P 519611

A REPAIR

**ON-SITE SEWAGE DISPOSAL SYSTEM
HOWARD COUNTY HEALTH DEPARTMENT
BUREAU OF ENVIRONMENTAL HEALTH**

ADDRESS: 5000 Sheppard Lane PROPERTY OWNER: Dorothy Mobley

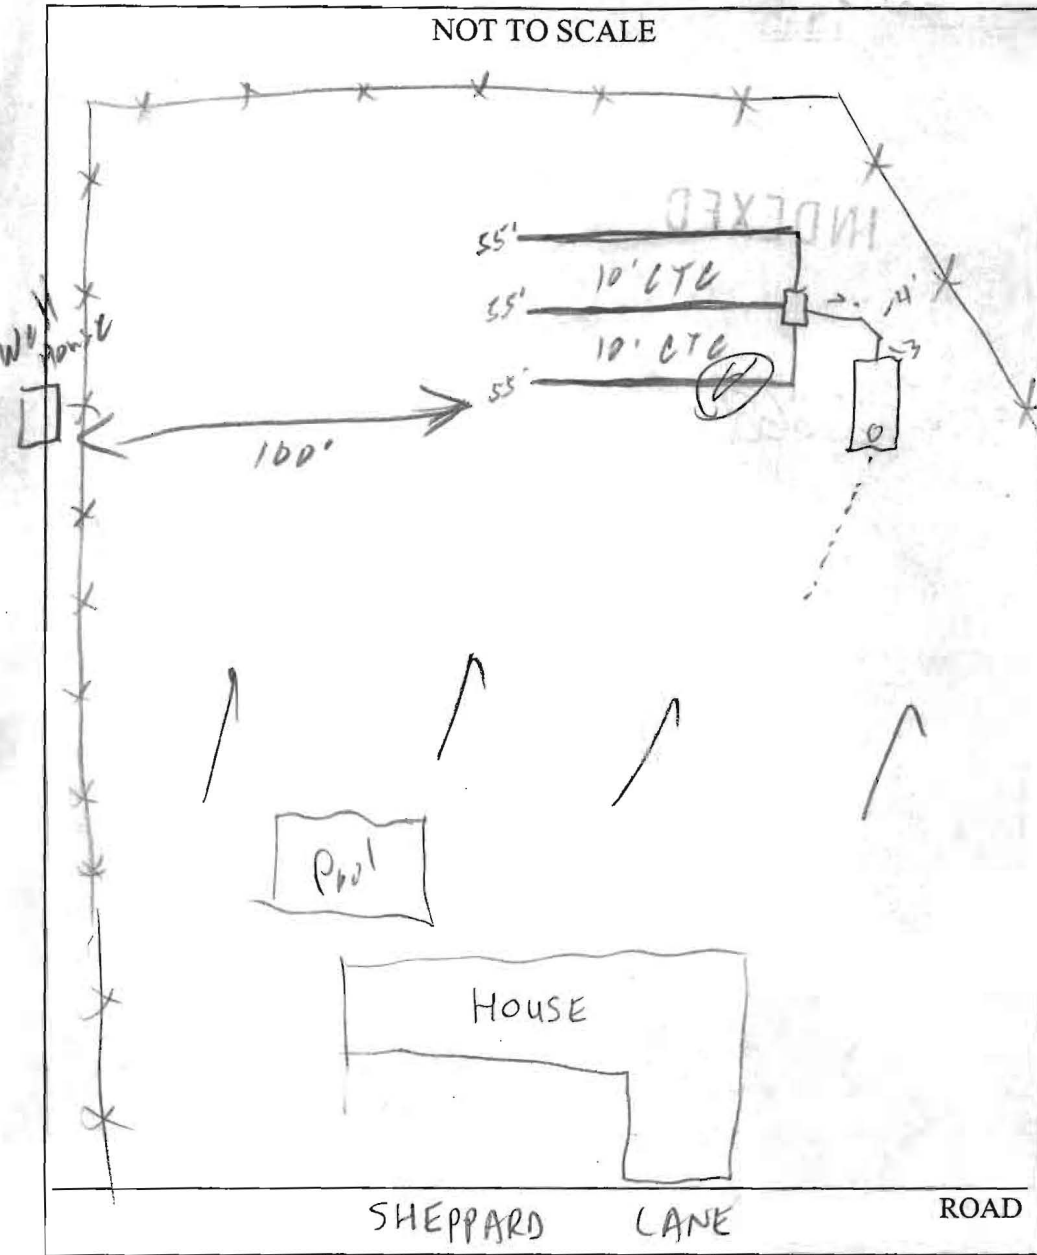
INSTALLATION 10/23/03 - phone call from contractor. Line from house is 5' below grade. Changed specs to 5' inlet, 10.5' bottom, 165' of trench SO/KB

10/24/03 - OK to cover all work. Top trench ∴ 6" too deep SO
